Informal document No. GRSP-45-02  
(45th GRSP, 25-29 May 2009,  
agenda item 14(a))

REGULATION No. 29  
(Cabs of commercial vehicles)

Proposal for a Revision to Regulation No. 29, incorporating the draft 03 series of amendments

Submitted by the secretary of the GRSP Cab Strength Informal Group

Fig. 1

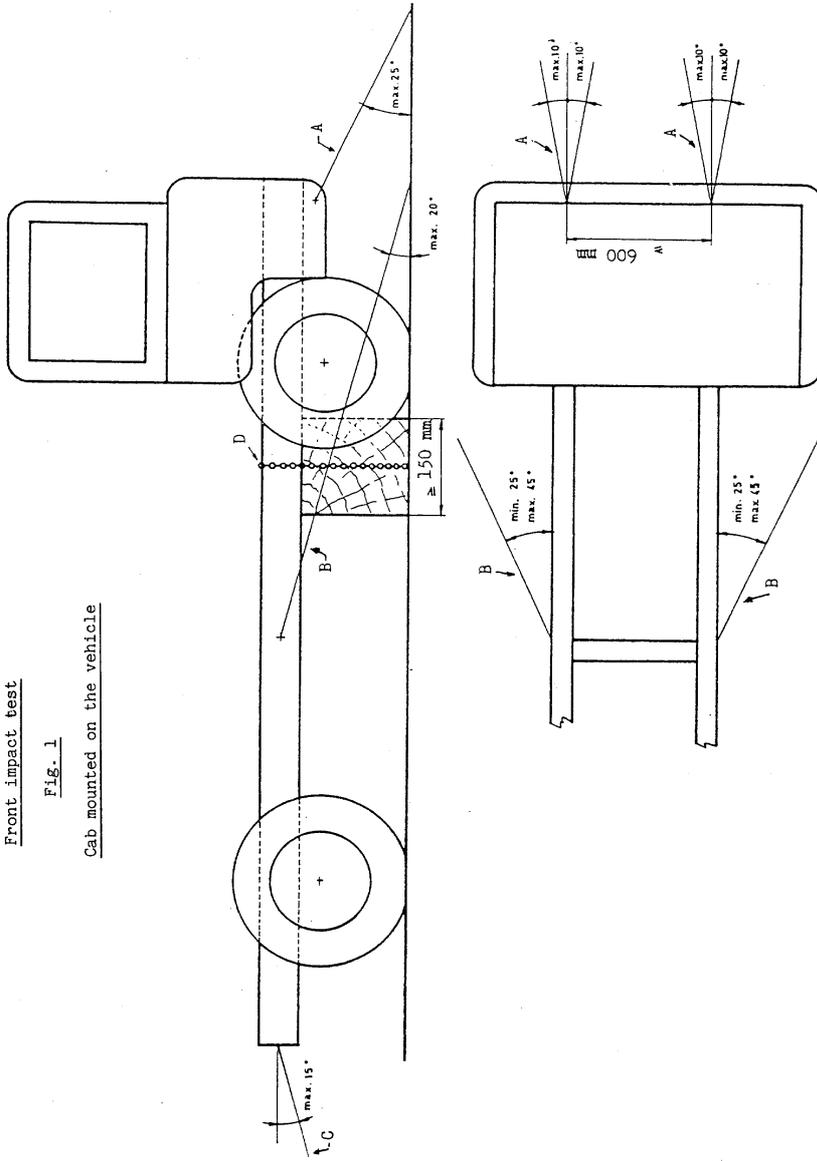
**Comment [G31]:** OICA  
 Comment: ECE/TRANS/WP.29/GRSP/2007/15  
 proposes the deletion of Annex 3 - Appendix 1.  
 OICA deem that this Appendix 1 should better to  
 be retained, after proper review and  
 amendments

~~Test A shall be applied to a cab mounted on the vehicle in the following way (see figure 1 below).~~

~~Rearward movement of the chassis frame shall be limited by chains or ropes A attached to the front of the chassis frame symmetrically in relation to its longitudinal axis, the points of attachment being not less than 600 mm apart. The chains or ropes shall when tensioned form a downward angle of not more than 25 ° with the horizontal and their projection on a horizontal plane shall form an angle of not more than 10 ° with the longitudinal axis of the vehicle. The chains or ropes may cross one another.~~

~~Lateral movement shall be limited by chains or ropes B attached to the chassis frame symmetrically in relation to its longitudinal axis. The points of attachment to the chassis shall be not more than 5 m and not less than 3 m from the front of the vehicle. The chains or ropes shall when tensioned form a downward angle of not more than 20 ° with the horizontal and their projection on a horizontal plane shall form an angle of not less than 25 ° and not more than 45 ° with the longitudinal axis of the vehicle.~~
